URBAN DESIGN BRIEF

MINOR ZONING BY-LAW AMENDMENT

SUBJECT SITE: 1280 TRIM ROAD, OTTAWA

REPORT DATE: JULY 2, 2024

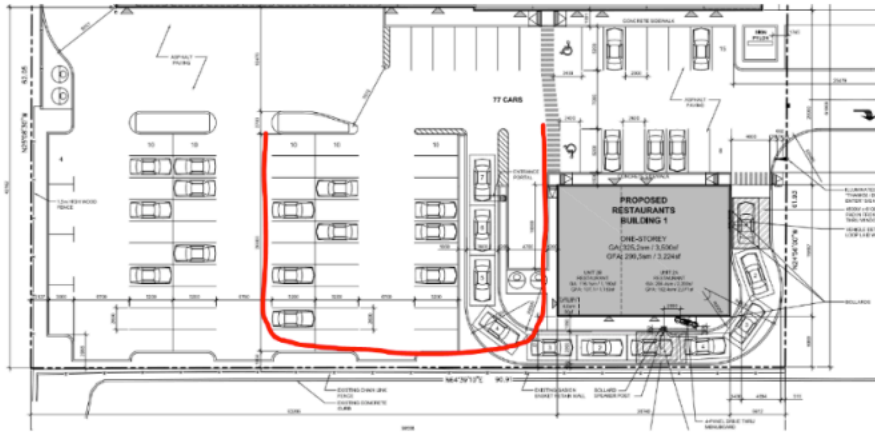
- [*Comment:* Drive-through Location: Staff do not support the request for a reduced width of a landscaped area abutting a street to 0.35 m whereas 3 m is required, as the relief requested is to accommodate a site design that Staff do not support. The restaurant building should have an active entrance from Trim Road, the drive-through facility should not be located between the building and the street. Instead, a seating area and bicycle parking should be next to the street, see figure three and four for a precedent of an A&W restaurant along Hunt Club Road where this was done. This would allow for an east-facing restaurant entrance and an unimpeded crossing for pedestrians. You should design the on-site circulation to minimize the conflicts between pedestrian and vehicles.

- [*Response:* The building has been pushed back to accommodate a 1.5 m landscape buffer with trees and landscaping to provide screening along Trim Road. The drive-thru location is complicated by a narrow site (which makes accommodating it on the correct side of the building/vehicle challenging). In order to avoid conflict with the stacking lane and other vehicular circulation, it has been located behind the building.

Figure 24: Massing model showing proposed buildings (green) within the existing context

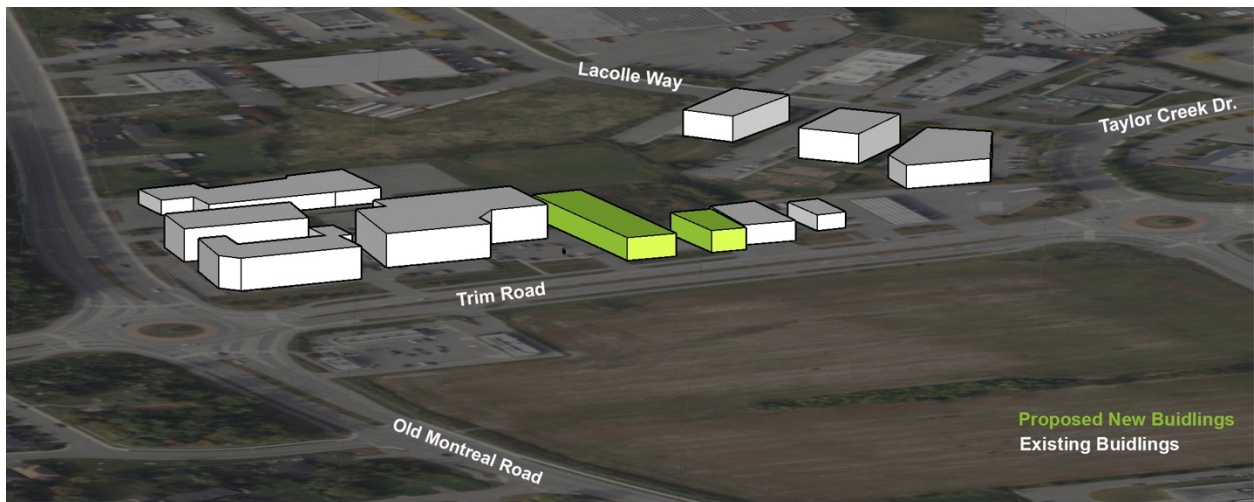
- [*Comment:* There is no discussion of the Orleans Corridor Secondary Plan in the Design Brief.
- [*Response:* The design brief has been modified to include a discussion of the Orleans Corridor Secondary Plan.
- [*Comment:* The description on page 25? (there are no page numbers) for figure 15 states that there are transit stops nearby. There is an LRT station north but where are the stops? This should be shown visually at a scale that can be understood a pedestrian walking distance.
- [*Response:* An additional graphic, Figure 19 was added to the report to show adjacent transit stops.
- [*Comment:* The Design Brief is missing “Massing of the proposed development in the existing context”. Please show this visually.

- [*Response:* An additional graphic, Figure 24, was added to show the proposed buildings within the existing context.
- [*Comment:* The Design Brief is missing an analysis of “Response to abutting public realm conditions beyond the boundaries of the site”. This should be shown visually.
- [*Response:* Shown visually in Figure 25.

02 SITE PLAN
SCALE: 1:250

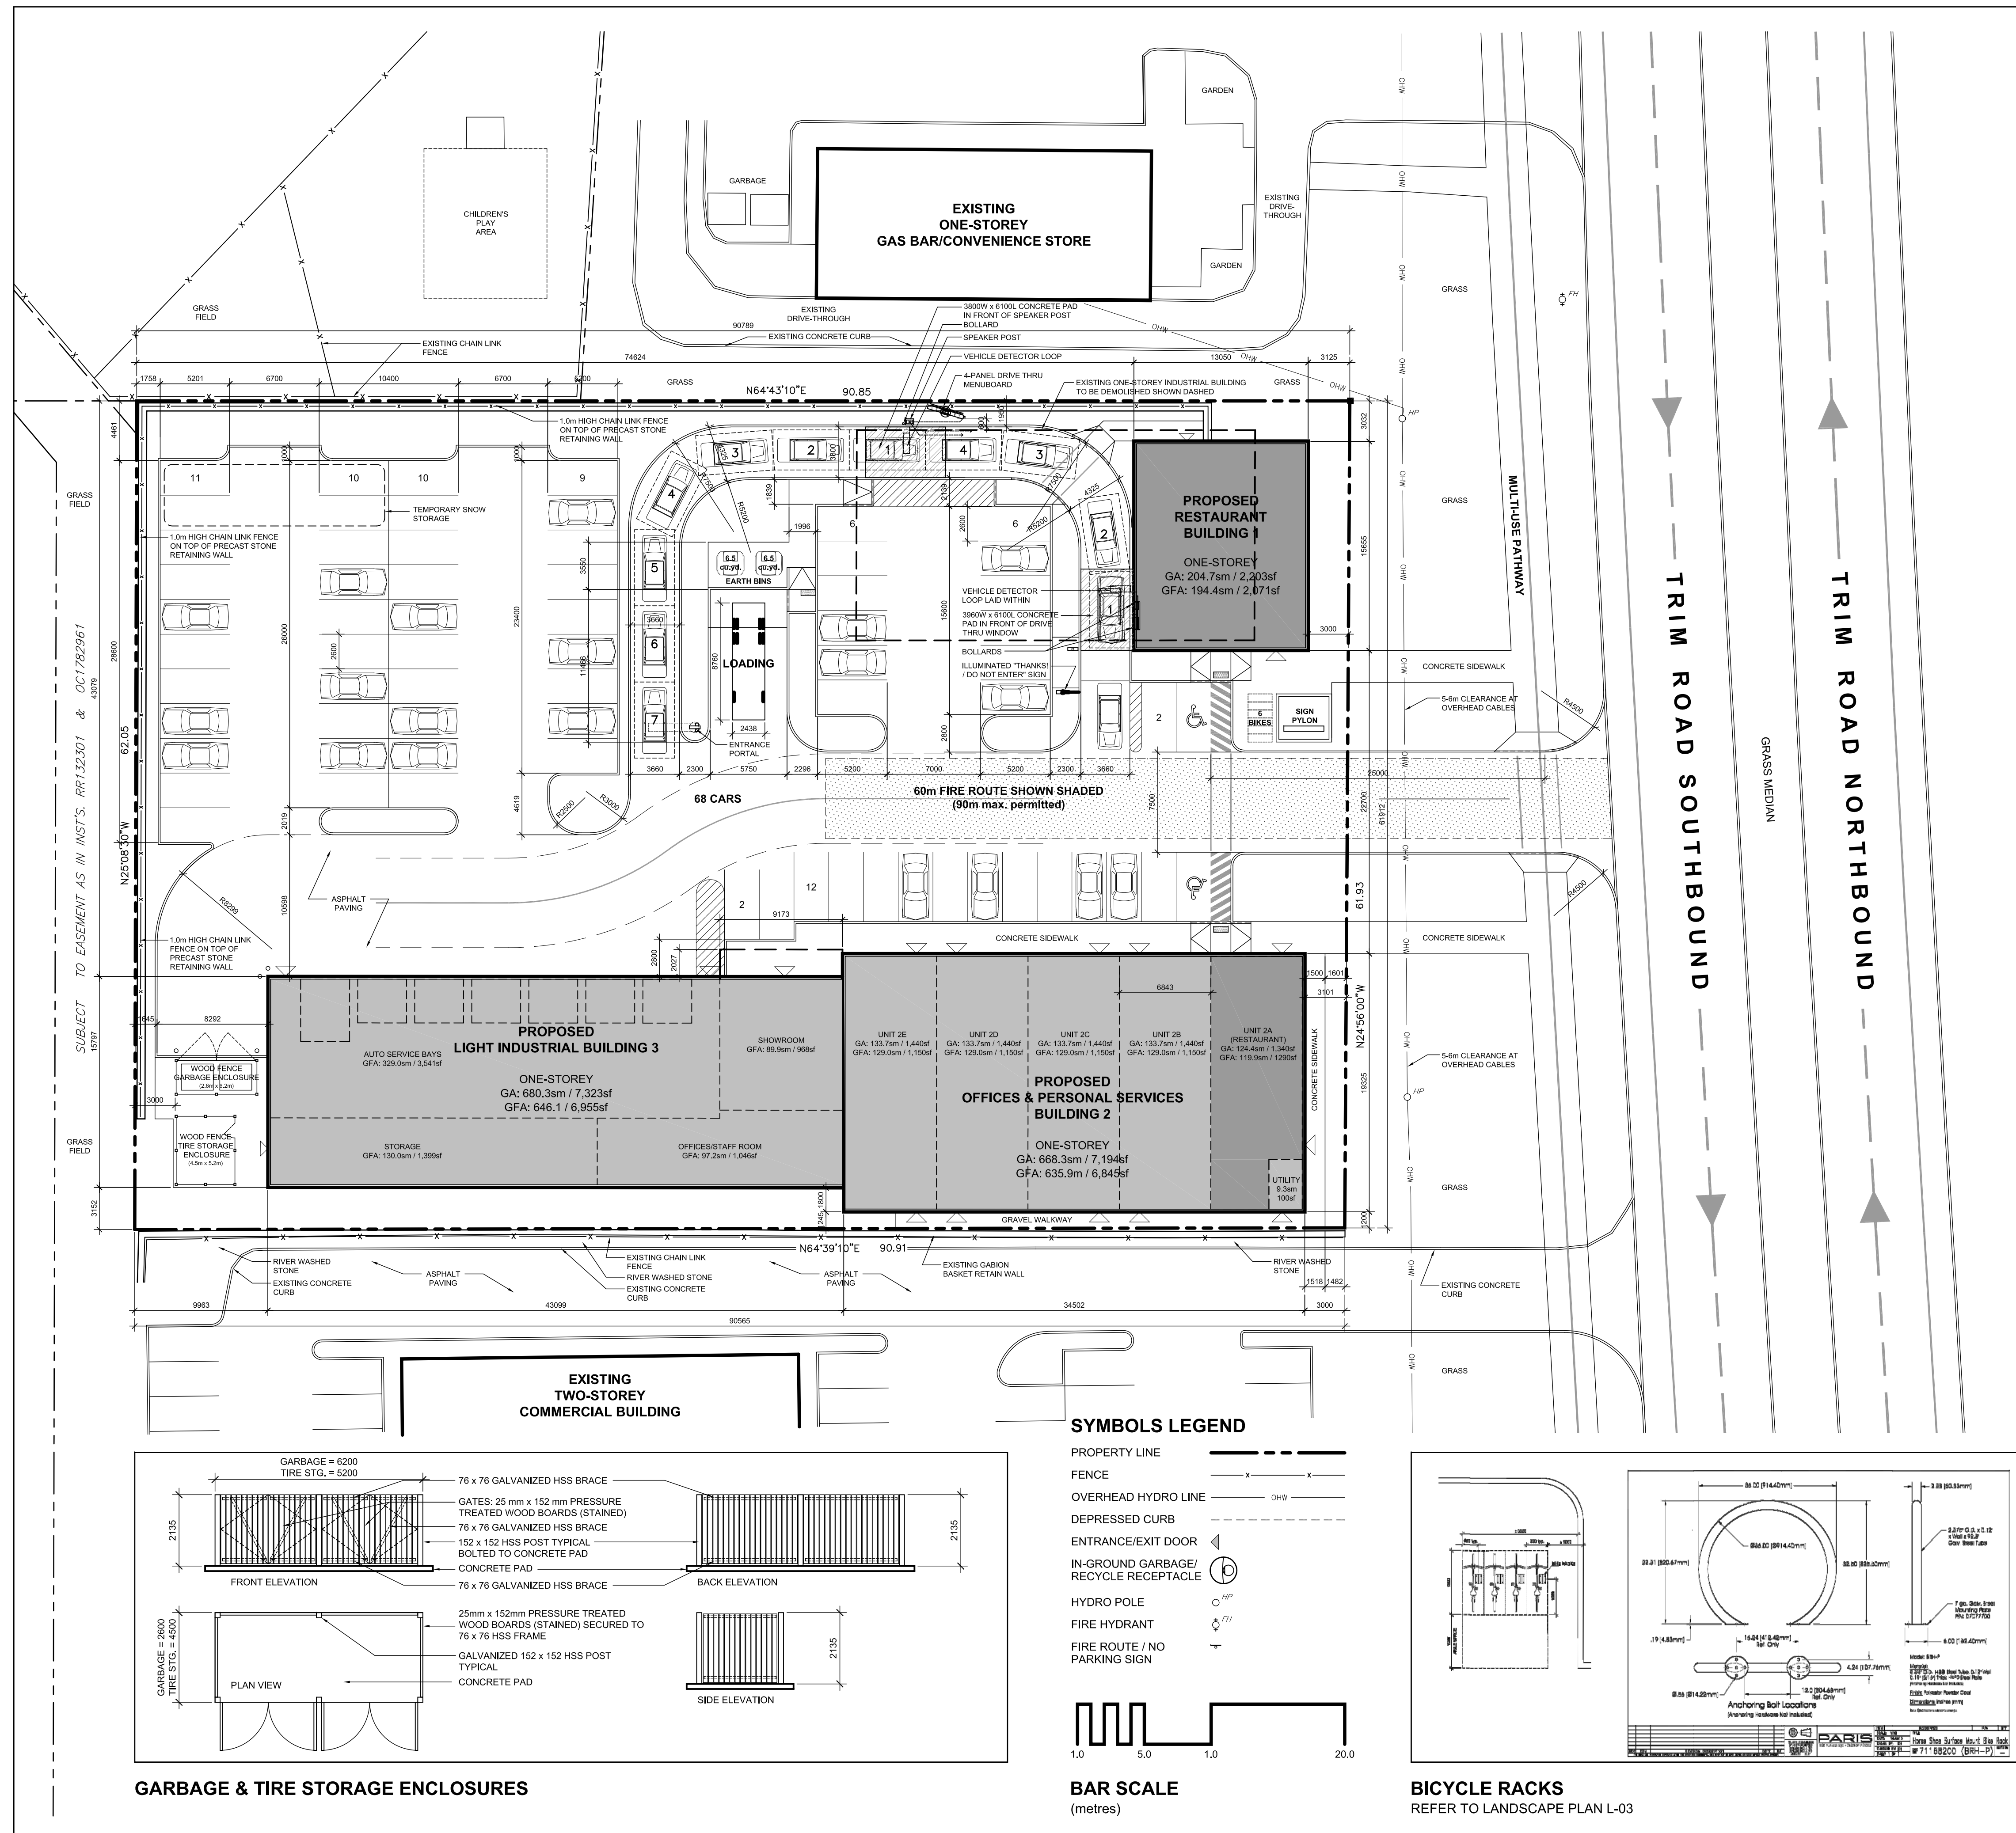
- [*Comment:* The multi-use pathway along Trim should be clearly demarcated to turning vehicles.
- [*Response:* The multi-use pathway has been clearly demarcated. See the revision to the site plan.

- [*Comment:* Please ensure there is a pedestrian crossing shown on the plan (MUP). Please show the snow storage location on both the Site Plan and Landscape Plan. Please locate this area away from new tree plantings to prevent undue pressure and damage to tree trunks. Please consider switching shrub plantings to columnar tree plantings on the north side of the site, behind the buildings. While its great to see so much planting, this would require a robust maintenance plan. The City objectives of increasing tree canopies would benefit if some shrubs in the area highlighted below could be changed to cedars or columnar deciduous trees. If there are plantings, pavers or landscape elements within the right-of-way (ROW), then a maintenance and liability agreement be required for those elements.

- [*Response:* A pedestrian connection will be provided on both the landscape and site plan. A 3 by 20 metres snow storage area is provided at the 4 parallel parking spots at back. A snow fence will be added during the winter months to protect the tree planting. The landscape plan has increased the tree canopy with 4 ornamental trees and 5

medium trees along the north side of the building which fits within the Geotech offset. 5 upright junipers plus 1 additional conifer is added behind the garbage enclosure.
